PLANNING COMMISSION

PLANNING REPORT

TO: City of St. Francis Planning Commission
FROM: Beth Richmond, Consulting Planner
DATE: December 9, 2020
SUBJECT: Concept Plan
APPLICANT: Anderson Companies, LLC (Greg Anderson)
LOCATION: Block 1 Lot 1 East Village Addition (property east of the Rum River and south of Bridge St.)
MEETING DATE: December 16, 2020
COMP PLAN: Commercial
ZONING: B-2, General Commercial; C, Conservancy; R-2, Single Family Residential

ST. FRANCIS SENIOR LIVING

① SD Site Plan
1" = 60'-0"

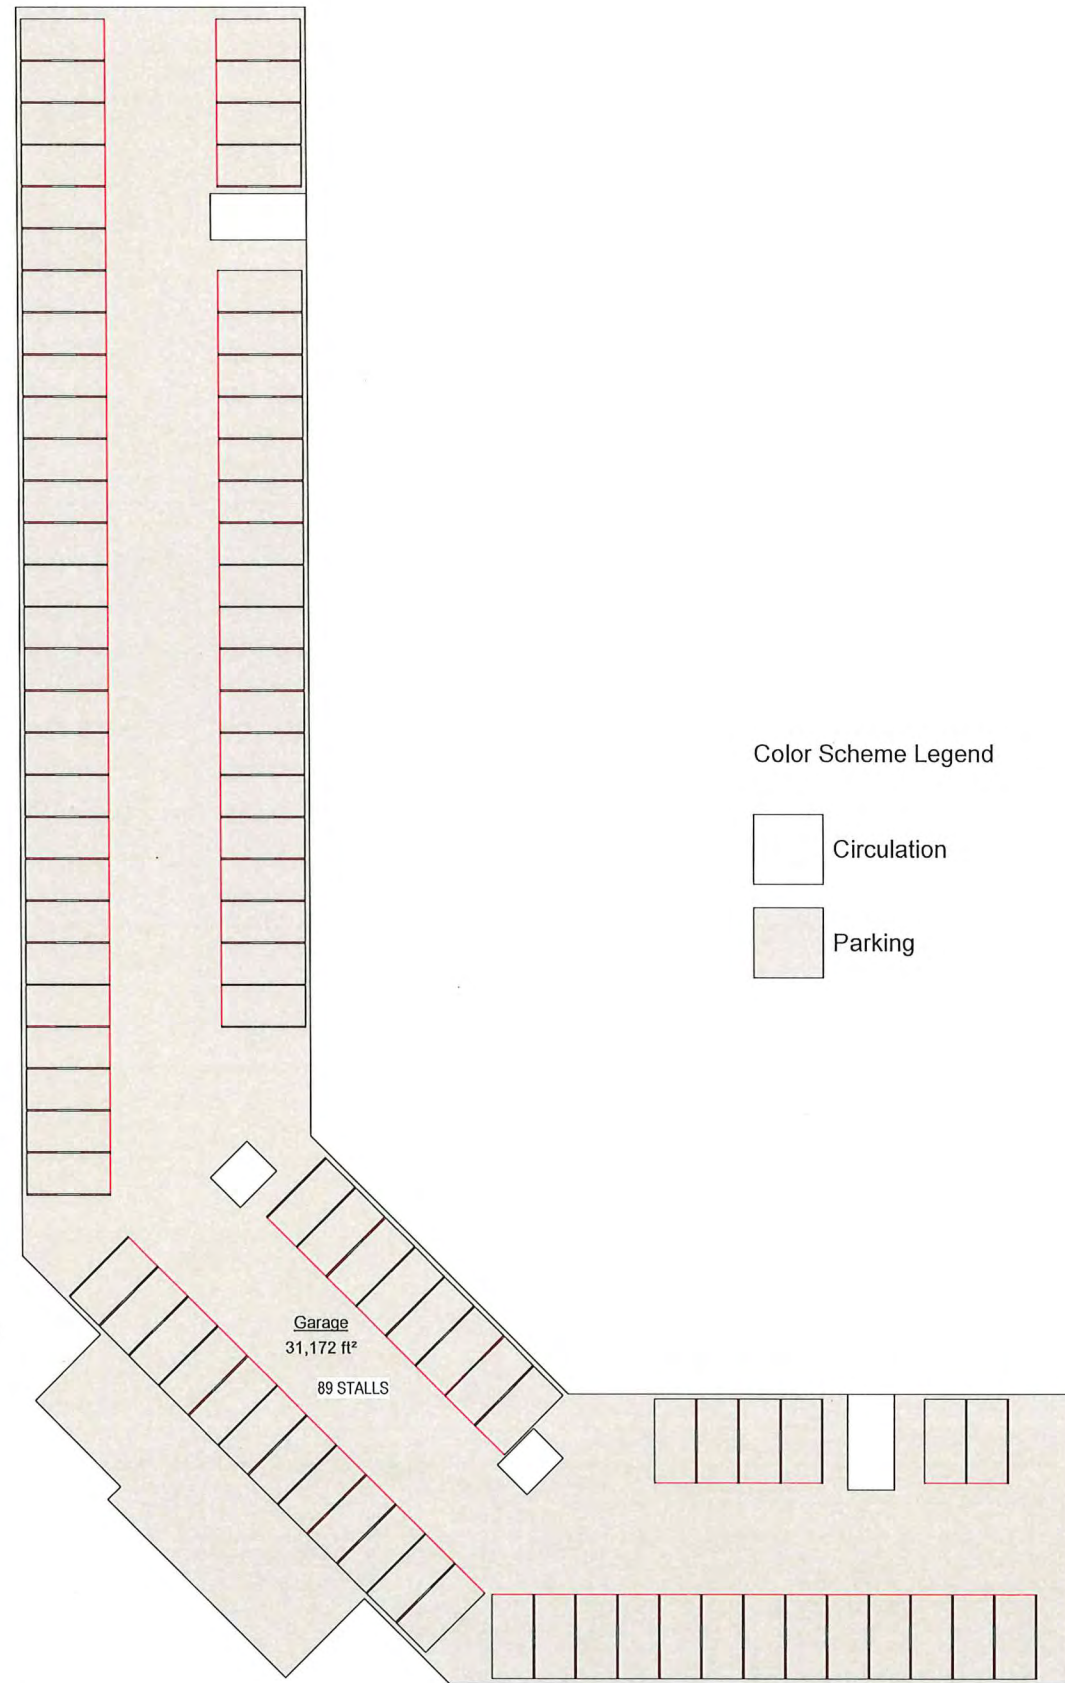
High density residential developments are required to be setback 50 feet from all R-1 and R-2 zoning districts. The concept adheres to this setback for the residential properties to the south. However, the park parcel to the west is currently zoned R-2, and so a 50 foot setback is required on the western side of the property as well. There are no homes on the property to the west, and the proposed structure would still be located more than 100 feet from the Rum River, so Staff is supportive of the conceptual layout. The zoning code update is planned to rezone the park parcel to the west to B-1, therefore a 50 – foot setback would not be needed if this concept were to be submitted following the zoning code update.

In the existing R-4 district, a 60-foot front yard setback is required for buildings and a 30-foot front yard setback is required for parking areas. The proposed concept shows the building roughly 30 feet from the right-of-way, meaning that the applicant would be requesting some flexibility from the existing front setback requirement. The 30-foot setback matches the front yard setback that will be required in the future R-3 district. However, in the design guidelines for Bridge Street, an important feature of development was to bring the buildings closer to the street. The preferred guideline for multi-family developments was to allow building extensions such as porches or balconies to reach up to the ROW line with the main building located no further from the ROW than 10 feet. Staff would be supportive of discussing how the applicant might reduce the front setback further, in line with the design guidelines, as a way to activate the streetfront along Bridge Street.

The driveway shown in the concept provides a turnaround for emergency vehicles and drop-off opportunities, which is supported by Staff. During the Fire Chief's review, he noted that a fire access lane would likely be required in order to reach the back side of the proposed building because of the distance of the building from Bridge Street. Reconfiguring the building to bring it closer to Bridge Street may change the need for or extent of this requirement.

- **Entry:** The guidelines dictate that a primary entrance to a site along Bridge Street should be oriented to the street. The concept pulls the building back off of Bridge Street, with the official

entrance to the building close to the south end of the site. The layout of the building and entryway does not encourage activity along Bridge Street.

- **Parking:** Staff is supportive of the proposed underground parking. Any surface parking should not dominate frontage on Bridge Street.
- **Rooftop:** Active rooftops are encouraged along Bridge Street. Staff suggests that the applicant consider creating a usable space or deck on the rooftop for residents.

- **Public Art/Public Plaza:** The building layout in the concept leaves a large amount of land near Bridge Street as open space. There may be an opportunity for a public plaza or public art to be included on the site near Bridge Street. The patio near the Rum River is a great amenity for residents, but again, what kinds of public amenities could be incorporated into this design to encourage an active, pedestrian-friendly Bridge Street frontage?

- **Stormwater:** A proposed stormwater pond is shown in the northeast area of the site. Stormwater management in the Bridge Street area should incorporate best management practices (BMPs) and is welcome to address stormwater in an innovative manner. Educational, landscape, and/or artistic elements are encouraged as part of stormwater treatments within this area of the City.

An existing County trail runs along the west side of this development. An easement is proposed to be created for the trail. No connections are shown from the trail to the development. Staff encourages the developer to work with the County on the possibility of providing access to that trail from the site. As part of the preliminary plan review process, Staff will reach out to the County Parks department for comments on the plan.
